**AGENDA**  
**HAILEY PLANNING & ZONING COMMISSION**  
**Monday, May 3, 2021**  
**Virtual Meeting**  
**5:30 p.m.**

## FINDINGS OF FACT, CONCLUSIONS OF LAW AND DECISION

**STAFF REPORT**  
**Hailey Planning and Zoning Commission**  
**Regular Meeting of May 3, 2021**

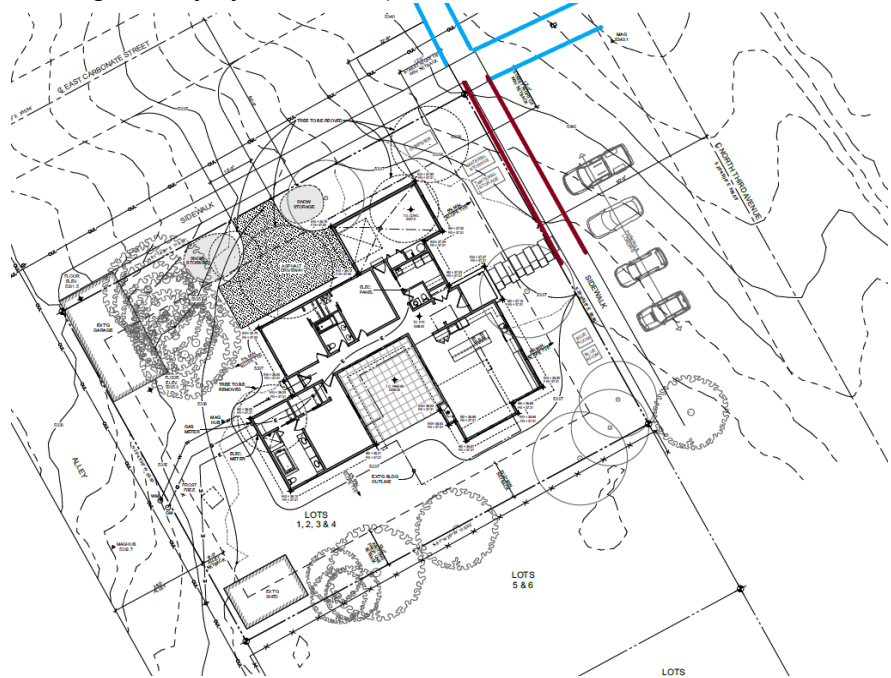
**Application:** The Applicant is proposing to construct a new 2,742 square foot single-family residence, which includes an attached garage, at 121 North 3<sup>rd</sup> Avenue. This is a corner lot. Access for the existing historic residence is located on Third Avenue. The existing residence will be relocated to another site in Hailey, and the two outbuildings, labeled ‘garage’ and ‘shed’, will remain onsite. This Application was heard by the Commission on March 1, 2021. The Applicant proposed that the garage gain access off of Third Avenue and not the alley, as called for in the TO District, and as noted herein.

As a general rule (pursuant Section 17.06.090(C)4 of the Hailey Municipal Code), garages and parking areas should be accessed from the alley side of the property and not the street side. Per feedback from the Commission at the March 1, 2021 public hearing, the Commission recommended that the Applicant look at reconfiguring the site plan to meet the standard or draft an alternative design for the Commission’s consideration. Further discussion of this standard can be found below.

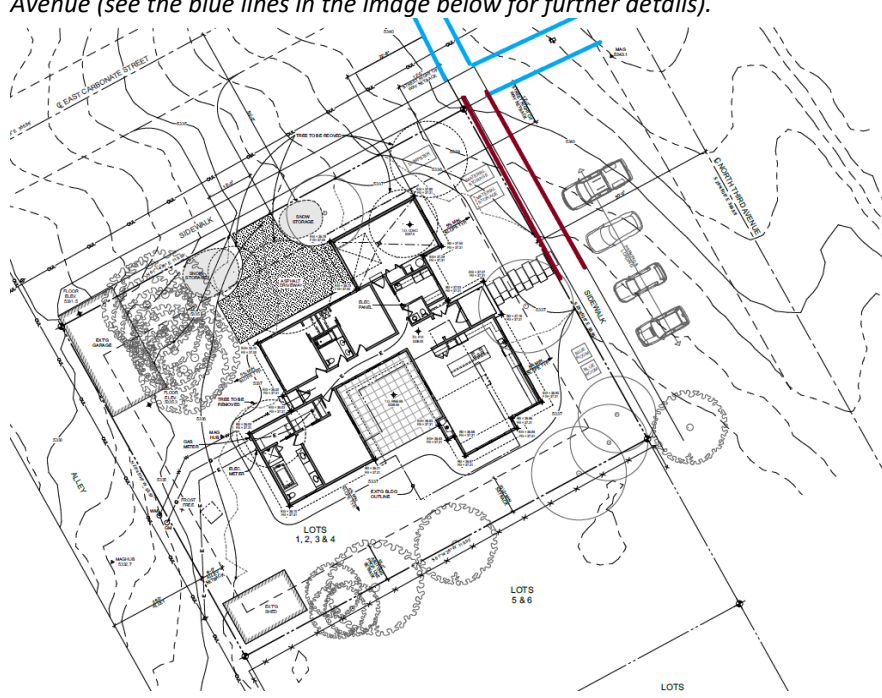
<i>Staff Comments</i>	<p>Maximum Building Height: 30'</p> <p>Proposed Building Height: 18'-1 5/8"</p> <p>Proposed Setbacks:</p> <ul style="list-style-type: none"> <li>○ Front Yard (East): 22'-6"</li> <li>○ Side Yard (North): 14'</li> <li>○ Side Yard (South): 21'</li> <li>○ Rear Yard (West): ~30'</li> </ul> <p>Proposed Lot Coverage:</p> <ul style="list-style-type: none"> <li>○ 3,622 square feet (Proposed Footprint + Existing Garage Footprint) / 11,979 square foot lot = 30%</li> </ul>

<p><i>The Commission found all setback, building height, and lot coverage requirements have been met.</i></p>
<input checked="" type="checkbox"/>	<input type="checkbox"/>	<input type="checkbox"/>	<p><b>17.06.070(A)1 Street Improvements Required</b></p>	<p><b>Sidewalks and drainage improvements are required in all zoning districts, except as otherwise provided herein.</b></p>
			<p><b>Staff Comments</b></p>	<p><i>Sidewalks are existing along the property frontage of Third Avenue and Carbonate Street. That said, the Public Works Department recommended and the Commission concurred that the sidewalk along Carbonate Street and Third Avenue be extended to the edge of asphalt on both Carbonate Street and Third Avenue (see the blue lines in the image below for further details).</i></p>  <p><i>The Commission found that the existing driveway, off of Third Avenue, be removed and the area be revegetated, and that the sidewalk along the property frontage and where the previous driveway was, be installed/repaired/replaced (see the red lines in the image above for further details). The existing sidewalks may also need some repairing. The Applicant shall repair the existing sidewalks, as outlined by the Public Works Department, prior to issuance of a Certificate of Occupancy.</i></p> <p><i>Furthermore, a detailed engineering plan with grading and drainage shall be provided prior to issuance of a Building Permit. The Public Works Department will need to review the final design before additional recommendations can be made.</i></p> <p><i>Comments above have been made Conditions of Approval and the Commission found this standard to be met.</i></p>

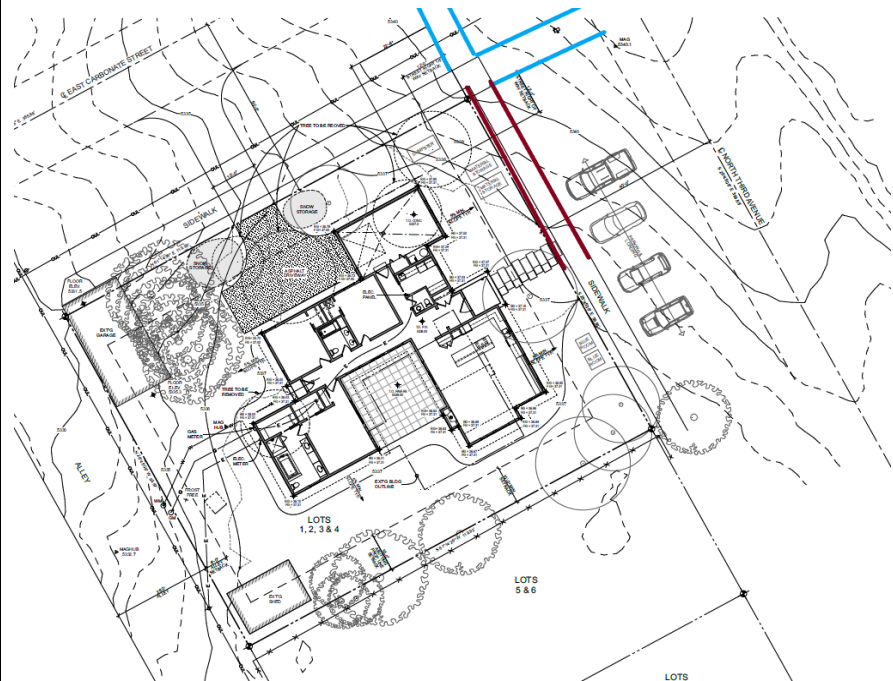
*Adequate parking has been provided. The existing driveway is 30' from the intersection of the two public roads, Third Avenue and Carbonate Street. In the original design, the Applicant proposed that the garage gain access from Third Avenue, where the driveway is approximately 14' from the intersection of these roads. Due to the proximity of the proposed driveway to the intersection, the Commission noted that, in addition to being inconsistent with Design Review Guidelines which direct vehicular access to alleys, the proposed driveway and garage would impede visibility of vehicular and pedestrian traffic coming from Third Avenue and Carbonate Street. The Commission strongly encouraged the Applicant to position the proposed garage and driveway off of the alley or reconfigure the site in differently.*

*The Public Works Department also recommended and the Commission concurred that the sidewalk along Carbonate Street and Third Avenue be extended to the edge of asphalt on both Carbonate Street and Third Avenue (see the blue lines in the image below for further details).*

*With the new configuration, the Applicant is proposing that the garage door face the alley; however, access be achieved from Carbonate Street. The Commission felt this reconfiguration was a more appropriate alternative to the original proposal.*
